From: Chelsea Gosden
Sent: Thursday, 27 July 2023 10:52 am
To: Robyn Edwards
Subject: FW: [EXTERNAL] Fwd: FW: BCO10364430-Section 37 covering letter(03)
Attachments: 230719 SITE PLAN 101E.pdf; letterac-362MatakanaRoad-001.pdf

THREE BLOKES LTD
REPLACEMENT MARKET SHEDS
362 MATAKANA VALLEY ROAD
MATAKANA

Re : BCO10364430- 362 MATAKANA VALLEY ROAD, MATAKANA

SHEET TITLE: **REVISION #:** **SITE PLAN 1: 500**

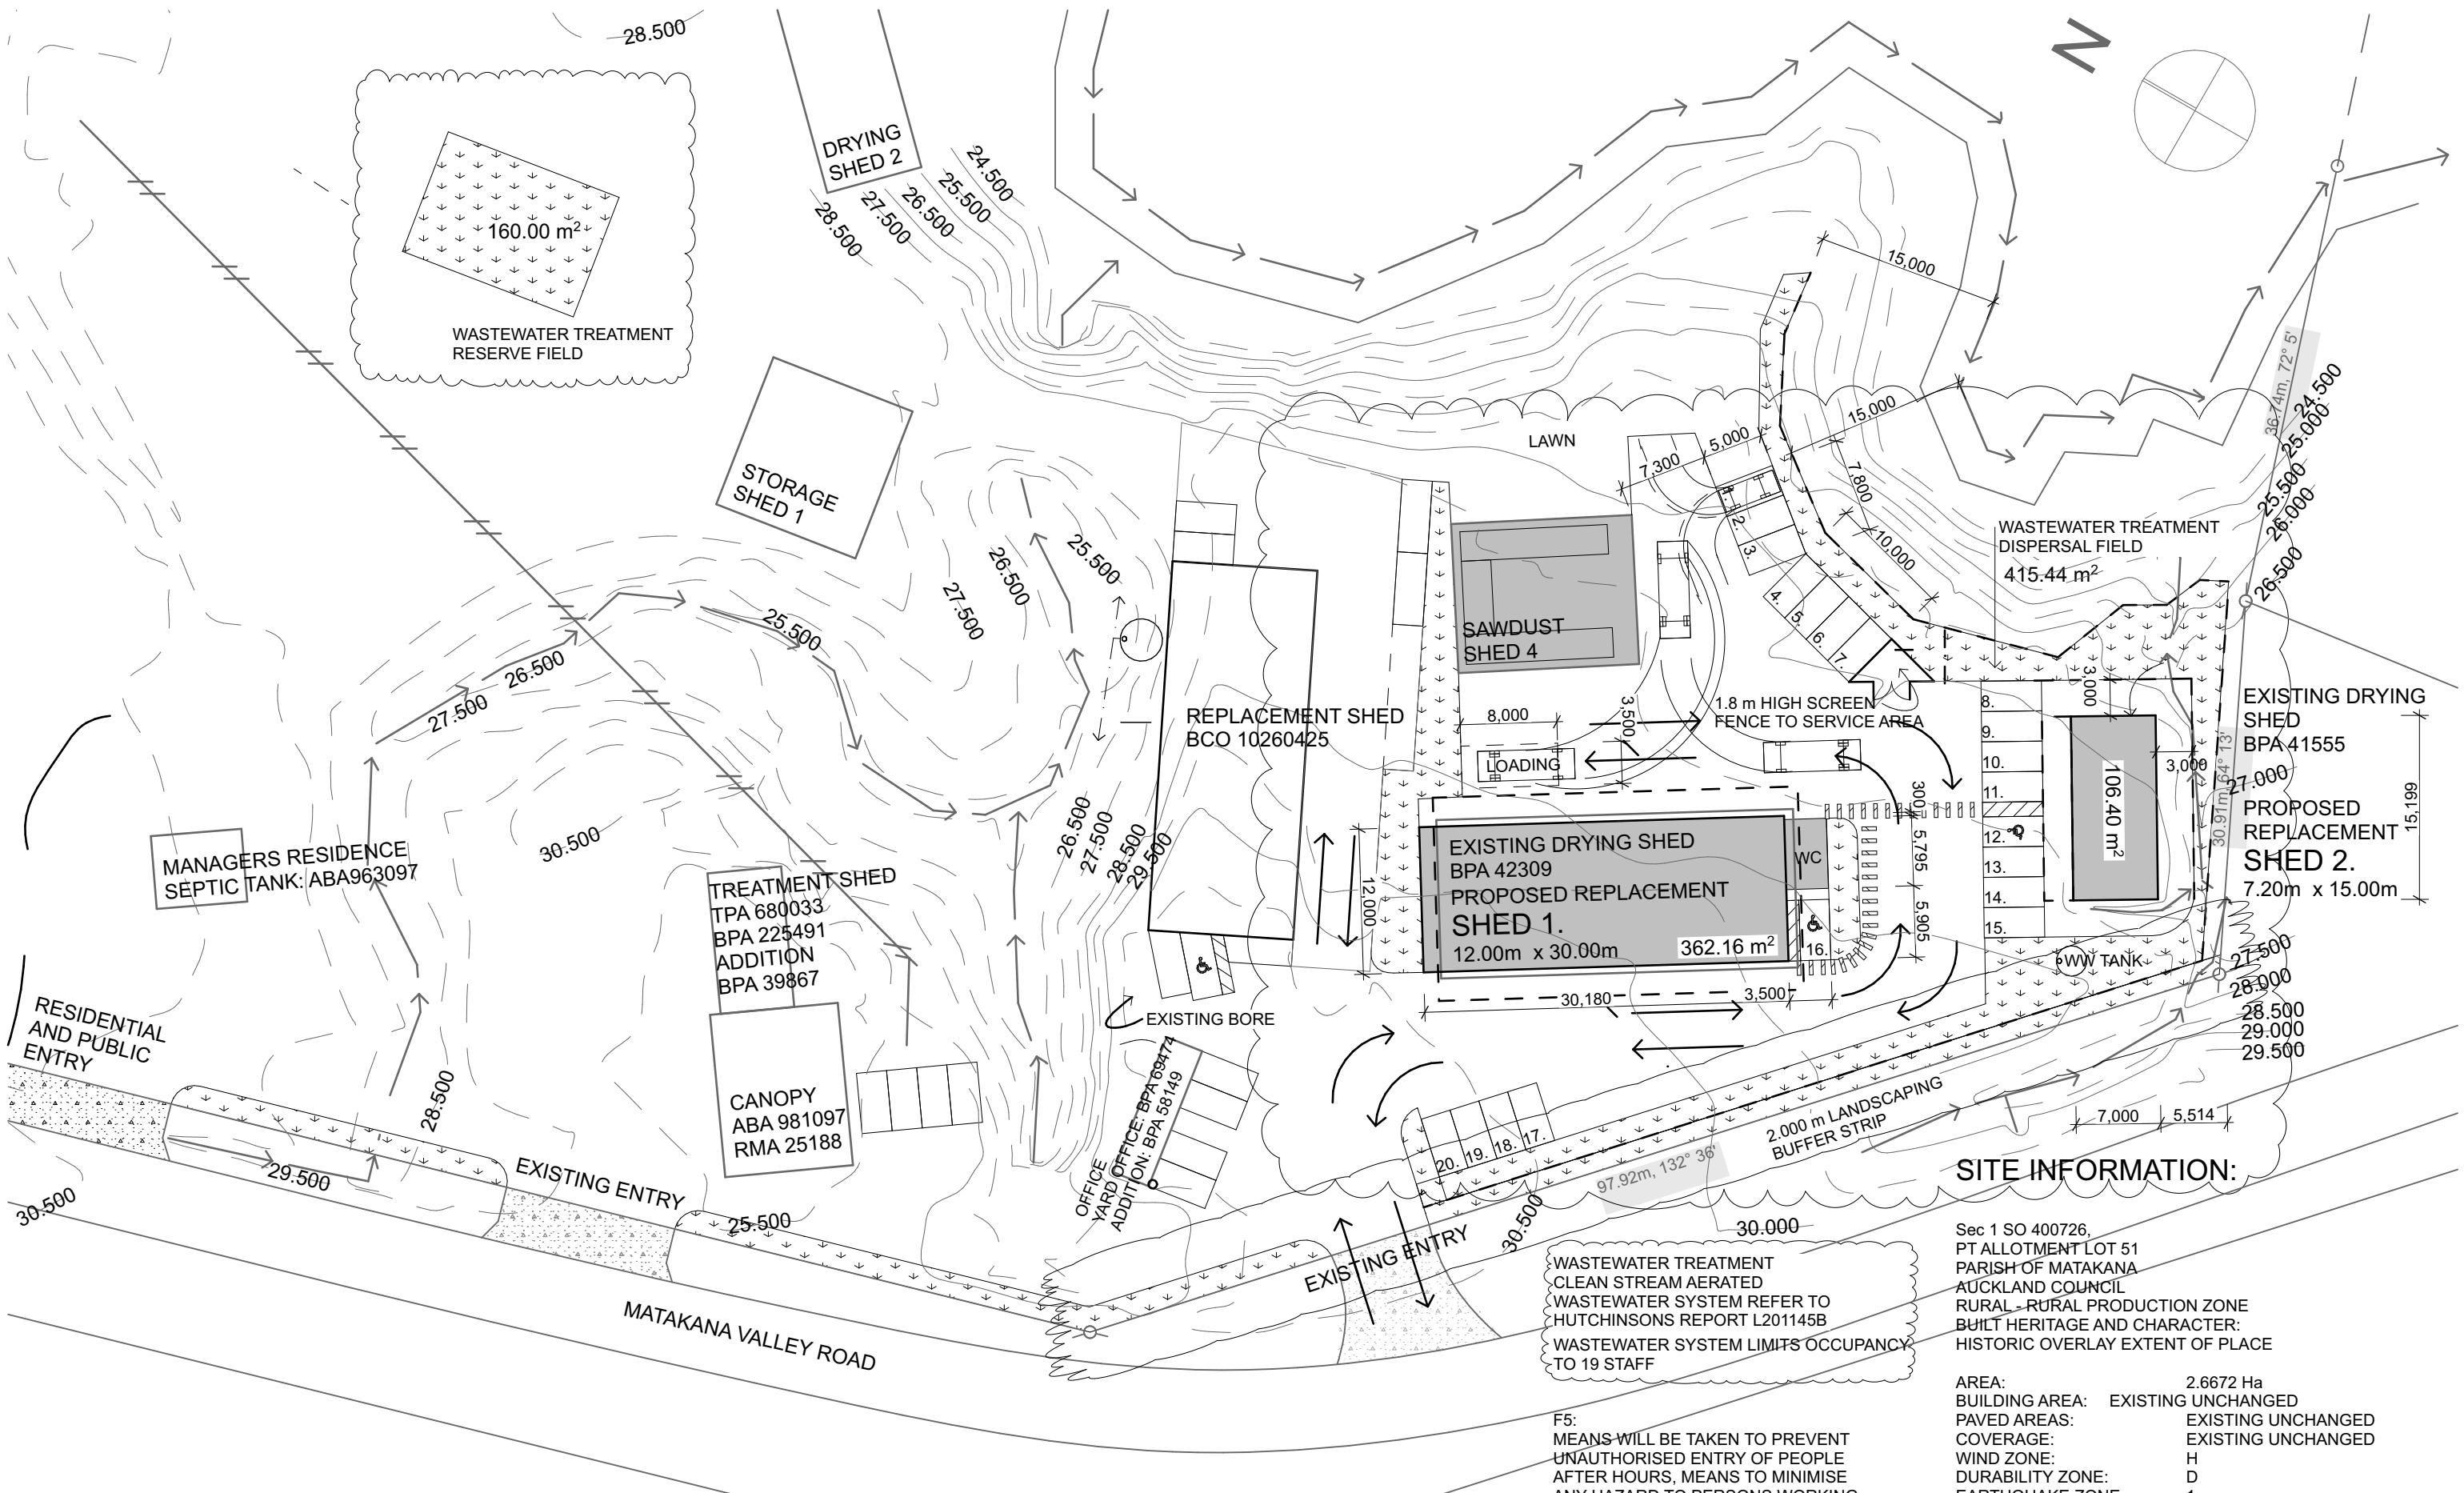
- 2.0 It is understood that a Section 37 Notice is in place until this matter is addressed.
- 3.0 As part of my instructions, and after reviewing the plans, I have recommended that a small adjustment be made to the car parking layout for car park spaces 1-3 to demonstrate compliance. This will mean, that once confirmation of being within scope is received, the currently submitted building consent plans will need to be updated.

- e) The most constrained car park spaces are 1 – 3, and the architect has overlain the tracking curves for your ease of reference. These spaces are 2.6 metres wide and have a maneuvering depth of 7.3 metres - thereby meeting E27.6.3.1.1 (T119).

5.0 We would be grateful if you could confirm that this minor site layout change is within scope, so that the building consent plans can be updated, the section 37 notice uplifted, and the building consent continue to be processed.
